Recall Information Bulletin
No: R3125410 **Issued:** 1/3/2005
Re: Fuel Injection Pipe Clamps
Group: 13 **Models:** FE, FH

Safety Recall R3125410 - Fuel Injection Pipe Clamps

FE640, FH210 equipped with a 4M50 engine assembly

PHOTO 1

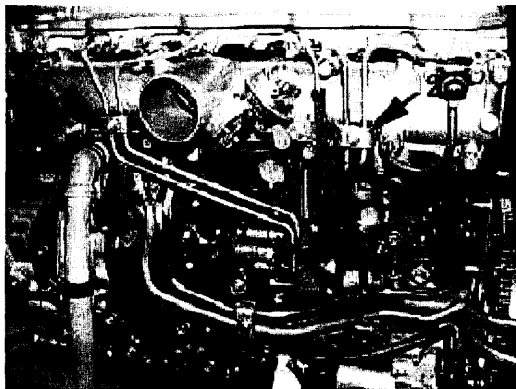
3. Remove the outer clamp at location 1 (as shown in PHOTO 1).
4. Install a new outer clamp (**MH020293**).
5. Apply a small amount of **Loctite 242 (or equivalent)** threadlocker on the threads of the existing stud.
6. Install a new spring washer (**MF450404**) and nut (**MF430004**) and tighten to **3.0 to 4.4 ft.lbs. IMPORTANT! DO NOT OVERTIGHTEN THE NUT!**
7. Clean off all excess adhesive.
8. Ensure that the thickness (**A**) of the assembled clamp is **0.81" to 0.85" (20.5 to 21.5mm)** after tightening (as shown in PHOTO 2). Repeat steps 3 to 6 if the measurement is outside of this specification.
9. Do not tighten or loosen the nut after proper specifications have been achieved. Loctite 242 cures to proper break-away strength after 24 hours.

10. Repeat steps 3 to 9 for the outer clamp at location 2.
11. Remove the outer clamp at location 3 (as shown in PHOTO 1).
12. Install a new outer clamp (**MH020293**).
13. Install a new bolt & washer assembly (**MH001852**) and tighten to **3.0 to 4.4 ft.lbs. IMPORTANT! DO NOT OVERTIGHTEN THE BOLT!**
14. Ensure that the thickness (**A**) of the assembled clamp is **0.81" to 0.85" (20.5 to 21.5mm)** after tightening (as shown in PHOTO 2). Repeat the steps 11 to 13 if the measurement is outside of this specification.
15. Do not tighten or loosen the bolt after proper specifications have been achieved. The yellow adhesive coating on the bolt threads cures to proper break-away strength after 6 hours.
16. Repeat steps 11 to 15 for the outer clamp at location 4.

PHOTO 3

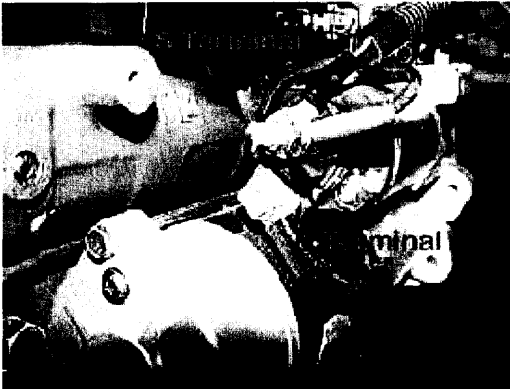
17. Examine the starter motor S terminal (as shown in PHOTO 3) for a protective rubber boot. **Note: Engines produced after August 2000 were assembled with the S terminal boot installed.**
18. If no boot exists, remove the S terminal harness, install a protective rubber boot (**ME753261**) over the S terminal (as shown in PHOTO 4), reinstall the harness, and tighten the harness retaining bolt to **1.48 to 1.84 ft.lbs.**

PHOTO 7

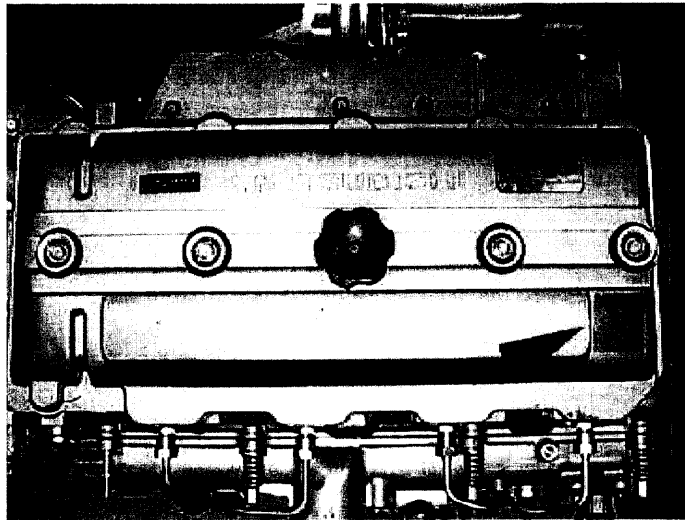
18. Clean and dry the left rear surface of the rocker cover (as shown in PHOTO 7).
19. Affix the caution label (ME224992) to the rocker cover in the red area indicated in PHOTO 7.
